SOLENOID TUBE GASKET INSTRUCTIONS

Refrigerating Specialties Division

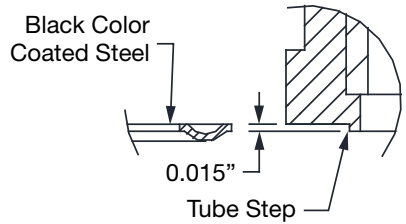
Old Aluminum Gasket/Tube
(Prior 6/22/12)

New Wolverine Gasket/Tube
(After 6/22/12)

Note: There are two different solenoid tube gaskets supplied in this kit. Appropriately match the existing gasket with the one in the kit. The gasket thickness will match the depth of the tube step as shown in the cross-sectional diagram above.

1. Remove knob and coil from the solenoid tube assembly
2. Unbolt the solenoid tube retaining nut, remove solenoid tube and plunger assembly
3. Replace the gasket (used same gasket in kit as what is being replaced)
4. Re-assemble in reverse order
5. Solenoid Tube Torque Specification:
 - Wolverine Gasket - 8.3 mkg (60 ft-lbs)
 - Aluminum Gasket - 15 mkg (110 ft-lbs)
